**SPD DATA REQUEST: SPD-SDGE-WMP2026-02**  
**SDG&E RESPONSE**

**Date Received: 07-01-2025**  
**Date Submitted: 07-24-2025**

**Figure 1: SUG Mitigation Effectiveness Based on All Ignition-Related Events**

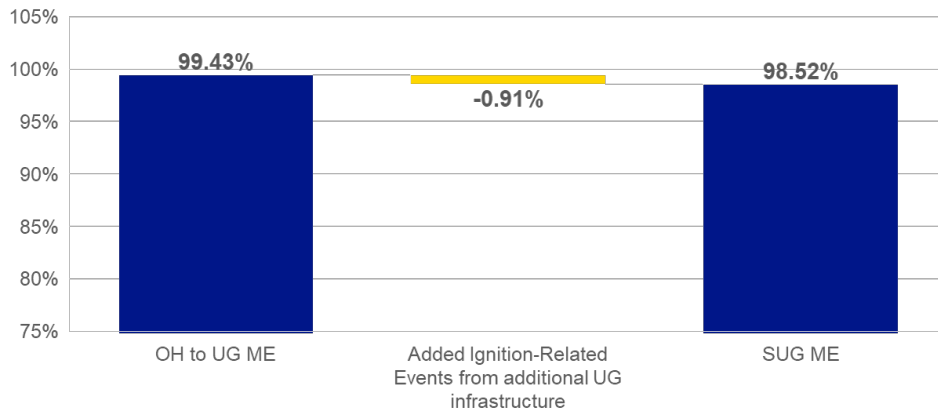
- b. Correct the mitigation effectiveness calculation to fix the arithmetic error which conflates the drivers for outage ignitions. The chart computes the mitigation effectiveness of undergrounding by comparing the number of ignitions from drivers before versus after being mitigated. However, the chart adds the drivers of underground ignitions to the drivers overhead ignitions, as an “ignition being mitigated.” These drivers of undergrounding ignitions will not be mitigated by undergrounding. In fact – the newly undergrounded lines will now be subject to these new set of underground ignition drivers – and so the number of undergrounding related ignitions to increase as lines are undergrounded.

After incorporating the estimated residual risk, the adjusted Mitigation Effectiveness of SDG&E's Strategic Undergrounding program is calculated at 98.52% (99.43% - 0.91%) as shown in Figure 1. This value is based on ignition-related events recorded between 2019 and 2024, reflecting a comprehensive assessment of both the benefits of removing overhead infrastructure and the minimal ignition-related risk introduced by underground systems.

Note that in the interest of maintaining a conservative modeling approach, SDG&E has elected to assume and model mitigation effectiveness for SUG of 98% in its WiNGS-Planning risk analysis, instead of the calculated value of 98.52%.

**Source: C0073-D, Sheet 3**

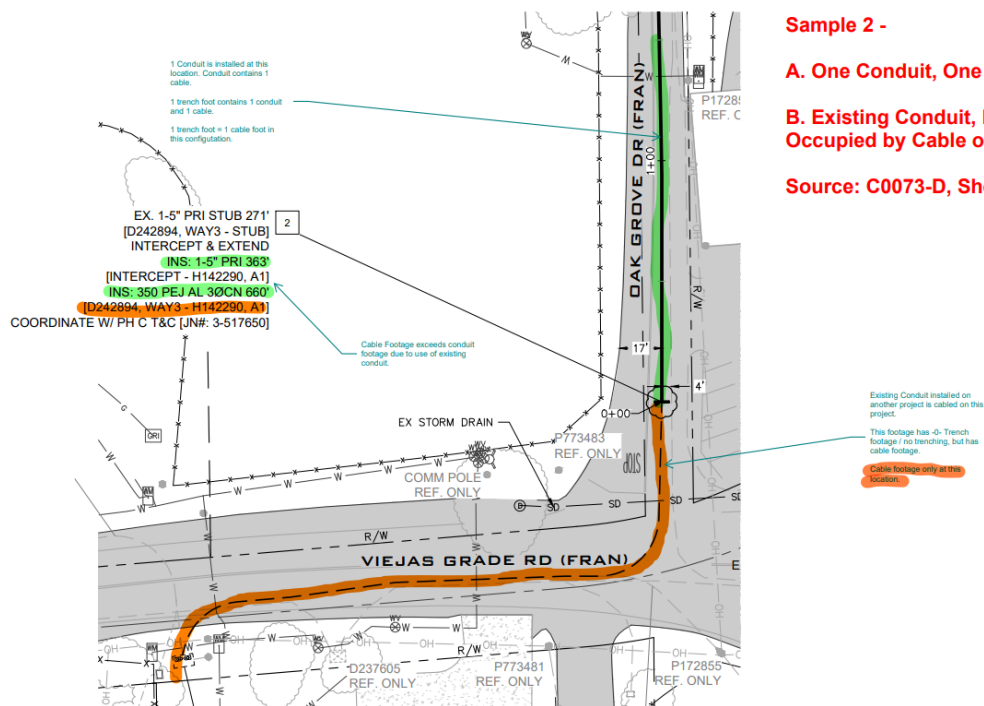
SPD understands that the work that SDG&E is performing is usually new work and so is confused as to how the energized mile only relates to existing work. Because of this, SPD is interpreting that the energized cost per mile is in addition to the trench cost per mile – and so understands that the full cost per mile of undergrounding is  $1.930 + 2.379 = \$4.309$  million per mile. If this is not correct, provide a diagram which shows the difference between energized miles and trench miles.

SDG&E calculates the energized mileage of Strategic Undergrounding Projects from the installed cable footage for each underground cable installed. It is a common and expected occurrence that a trench may contain as few as one single conduit and cable, or as many as 10 conduits and cables, depending on the number and density of meters; the position on the line segment relative to the source and the load; the proximity or distance to isolation and switching devices; availability of existing, unoccupied conduits to the desired location; and other engineering factors which are considered during design.

In the provided table below, the specified quantities of 36.59 Energized Miles and 29.70 Trench Miles represent the same work – 29.7 miles of trench were used to install 36.59 miles of energized cables. In general, SDG&E contracts for both the design and construction of this work on a per-project basis, and the unit cost, either by Energized Miles or Trench Miles is calculated by dividing the total recognized cost (subject to the assumptions provided in the cost figure for what costs are included therein) by the units of work which were completed using those dollars.

The provided table seeks to clarify that because fewer trench miles are required than energized cable miles, the cost per trench mile is higher than the cost per cable mile. These figures **are not additive**, as they represent different evaluation criteria of the same total cost, outlined in the leftmost column. The Total Cost of the Project, represented in the second column from Left labeled “Total Cost”, may be divided by the Trench miles (column 3) or the energized miles (column 4), depending on purpose of the reporting. These values for Trench and Energized miles **are not additive**, as they represent the same total cost value.

As illustrated in the diagram above, the section highlighted in brown utilizes existing conduit infrastructure. Therefore, only the cable length needs to be accounted for, and the appropriate cost metric in this case is the energized cost per mile.
